Access Compliance Report

Public Rights-of-Way

(Curb Ramps)

Intersection ID: 30460	Main Street: CRESCENT_EXECUTIVE_DR	Cross Street: ARROWOOD_RD	Location: NW
ADA ID: 7D820879865F	Ramp Type: PerpDiag	Initial Pass/Fail: Fail	Overall Compliance: No
Severity Score: 12.5			
Codes/Mitigation Info/Possible Solution		Field Measurements/Component Compliance

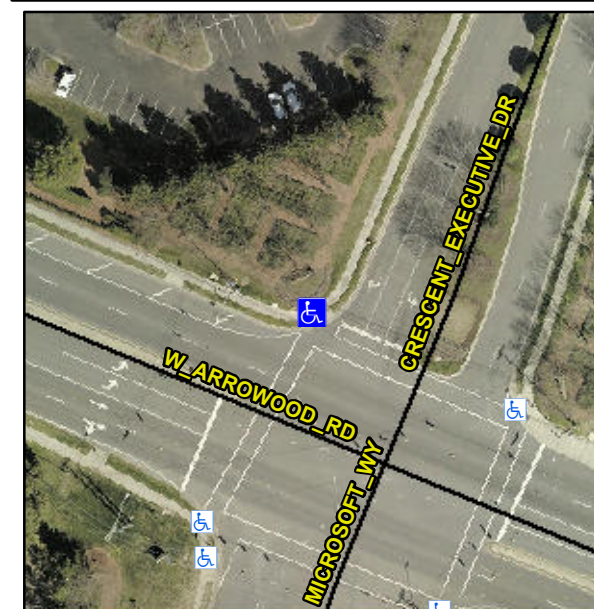
R304.5.3

Compliance	Description	Data	Compliance	Description	Data
N/A	Ramp Length (in)	108.0	Yes	Ramp Slope (%)	6.7
Yes	Ramp Width (in)	56.0	No	Ramp XSlope (%)	6.3
N/A	Flare Type LT	N/A	N/A	Flare Type RT	N/A
N/A	Flare Slope LT (%)	N/A	N/A	Flare Slope RT (%)	N/A
N/A	Flare Traversable LT?	N/A	N/A	Flare Traversable RT?	N/A
N/A	Landing Length (in)	N/A	N/A	DWS Provided?	N/A
N/A	Landing Width (in)	N/A	N/A	DWS Contrast?	N/A
N/A	Landing Slope (%)	N/A	N/A	DWS Length (in)	N/A
N/A	Landing X Slope (%)	N/A	N/A	DWS Full Width?	N/A
N/A	Landing Curb? (Y/N)	N/A	N/A	DWS Offset (in)	N/A
N/A	Shared Landing?	N/A			
N/A	Gutter Ponding?	N/A	N/A	Gutter Slope (%)	N/A
N/A	Gutter Lip Ht (in)	N/A	N/A	Gutter X Slope (%)	N/A
N/A	Painted X Walk1?	Yes	N/A	Painted X Walk2?	Yes
	X Walk 1 Direction	To SW		X Walk 2 Direction	To SE
N/A	X Walk 1 Width (in)	108.0	N/A	X Walk 2 Width (in)	108.0
	X Walk 1 Slope (%)	8.2		X Walk 2 Slope (%)	1.0
	X Walk 1 X Slope (%)	0.3		X Walk 2 X Slope (%)	4.9

Remove & Replace Curb Ramp With Two New Directional Ramps or Equivalent. Restripe Crosswalk.
